Peoples Street RFQ Q&A Responses

Published on 2/26/26

575 PEEPLES ST SW REZONING PLAN (SPI-21 SA8) "EXHIBIT B"

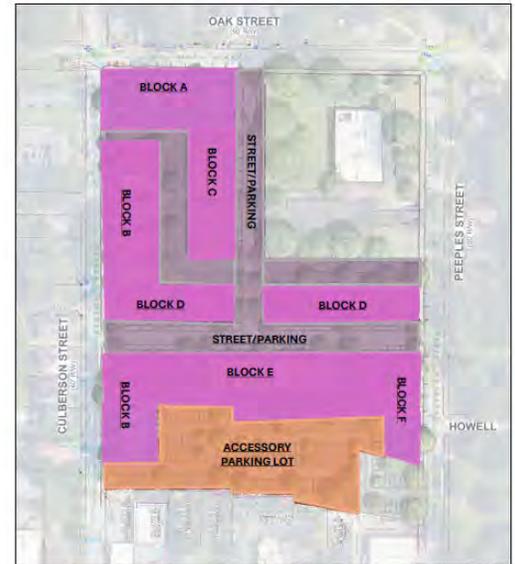
1. The RFQ references approximately eleven (11) for-sale units but does not identify their typology or location.
 - a. Is the expectation that these units be single-family detached, duplex, or townhome product? **The expectation outlined in the approved zoning is that they would be either single-family detached or duplex to match the surrounding neighborhood character and density.**

- b. Is there a preferred location within the site (e.g., perimeter-facing only)? **Yes, these units should be perimeter facing on Oak St and Culberson St.**

1. The master plan diagram indicates two mixed-use structures.
 - a. Is a commercial component required? **No, the zoning mandates no commercial on the site per neighborhood and NPU approval. Please see the approved zoning exhibit at the bottom of this document. The image shared at the site tour/Q&A session was a previous iteration of the rezoning exhibit.**
 - b. If so, what square footage is anticipated? **N/A**
 - c. Is neighborhood-serving retail preferred? **N/A**
 - d. Is 100% residential permitted if market conditions do not support retail? **Yes, 100% residential is planned.**

For reference, see the image on the final page of this document. This is the approved rezoning exhibit, which was included in the RFQ appendix.
